Technical Service Bulletin Notification TSB #18-017
Unit Serial Number:

Manual Override Access for Front Jacks

TSB # 18-017
 Job Code: 9804414
 Flat Rate: .3 Hour

Publication Date: October 2018
 Make: Highland Ridge
 Model: Ultra Lite FW
 Light FW
 Model Year: 2018-2019

FIG 3

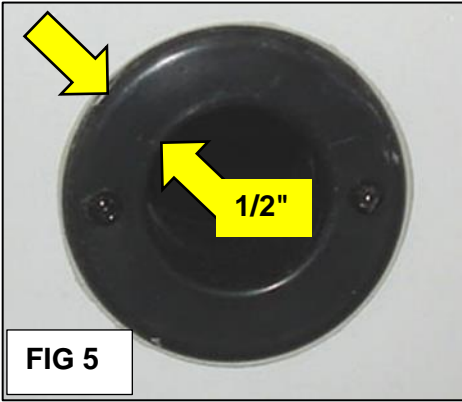
Measure from the front edge trim toward rear of RV 6-1/2"

FIG 3: Measure back to the rear of the fifth wheel, from the front edge trim, 6-1/2 inches. Make another mark with the erasable marker, pen or pencil. This locates the center of the access hole for the manual override.
FIG 4: Before drilling; make sure there will be enough clearance so the grommet does not come into contact with the switch or the compartment edging and that it sits flush to the outer wall.

FIG 4

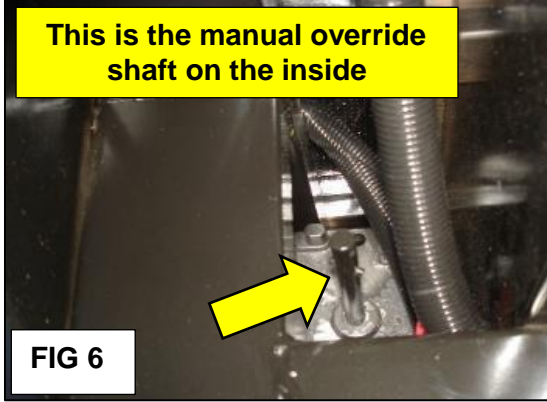
Make sure grommet will not interfere with the switch above

FIG 7

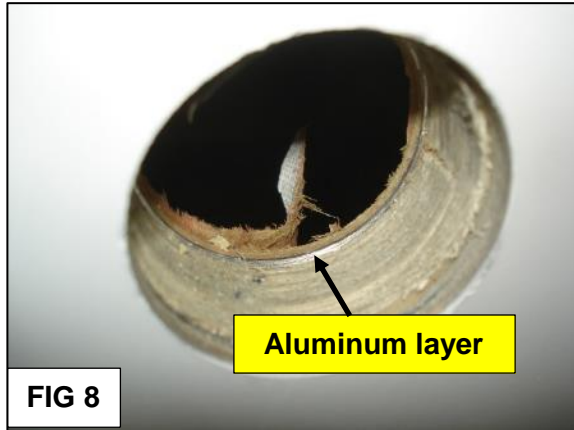
FIG 7: Drill the 2 inch diameter hole when the location has been finalized.
FIG 8: While drilling, you will enter through a thick layer of wood followed by a thin layer of aluminum.
